ENGINEERING STUDY / ANALYSIS REPORT

SUBJECT : NOISE AND DC LEVEL FOR DCDC IC MC33063ADR PCN

PURPOSE : STUDY NOISE AND DC LEVEL FOR DCDC IC MC33063ADR PCN# 20230417002.1
(Qualification of new Fab site (RFAB) using qualified Process Technology and Die)

MODEL NAME : 8AC22CX1
PART NO. :
SUPPLIER / MAKER :
STUDY STAGE : EVT / DVT / PVT / 1ST LOT / OTHERS:
SAMPLE STAGE : 1ST / 2ND / 3RD SAMPLE / OTHERS:
CHANGE DCDC IC MC33063ADR PCN# 20230417002.1

DCDC IC MC33063ADR NOISE**Current DCDC IC MC33063ADR****DCDC IC MC33063ADR PCN# 20230417002.1****DCDC IC MC33063ADR DC LEVEL****Current DCDC IC MC33063ADR****DCDC IC MC33063ADR PCN# 20230417002.1**

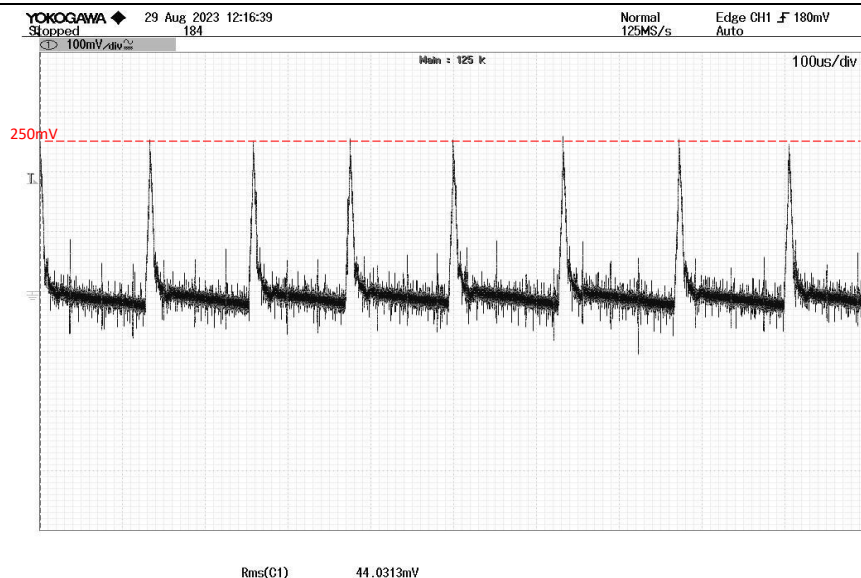
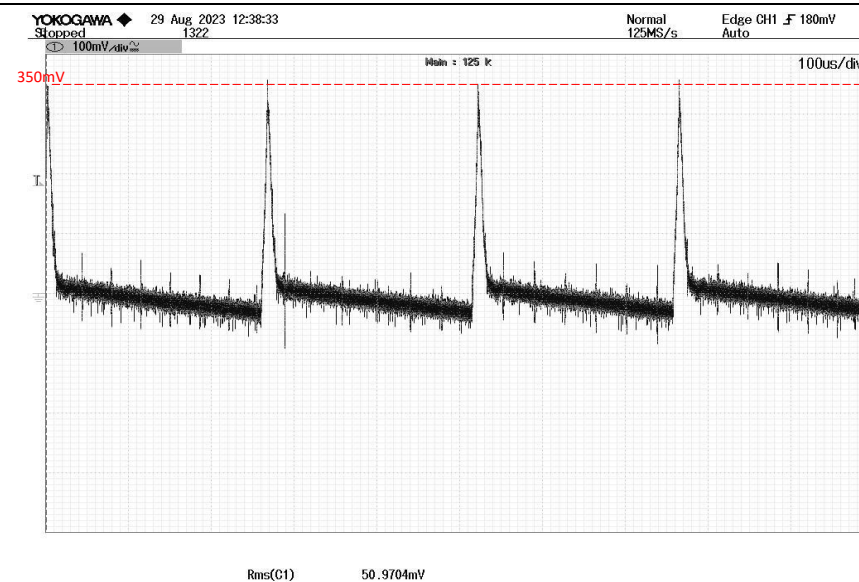
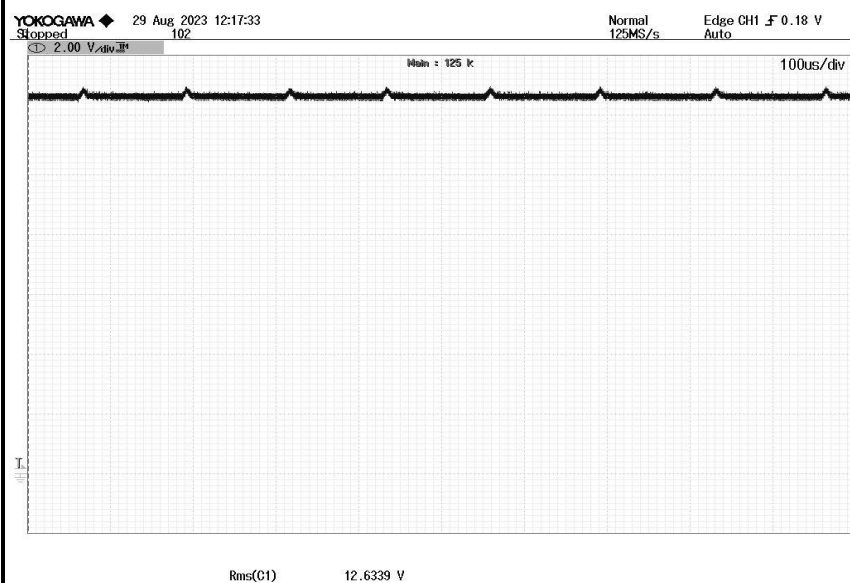
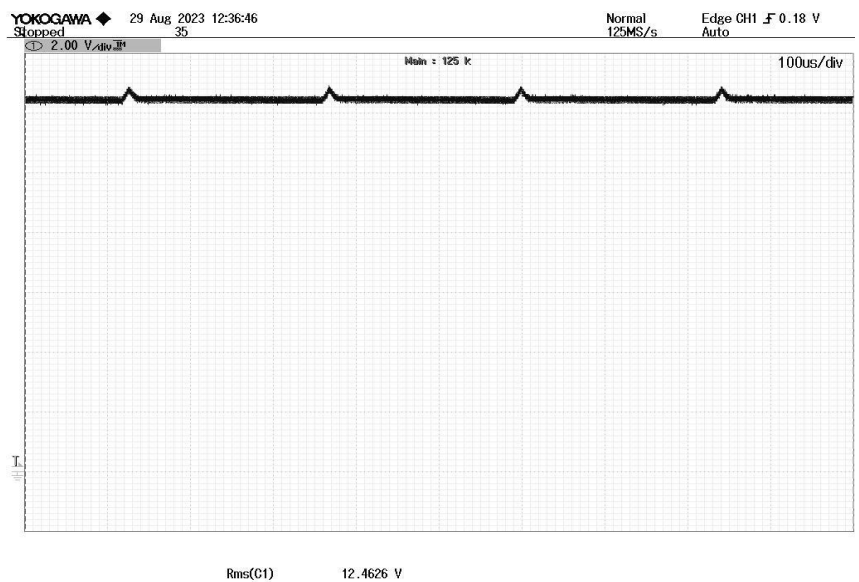
2.1 OBSERVATIONS / FINDINGS :
1. Noise level for MC33063ADR PCN# 20230417002.1 increase 40% compare previous MC33063ADR
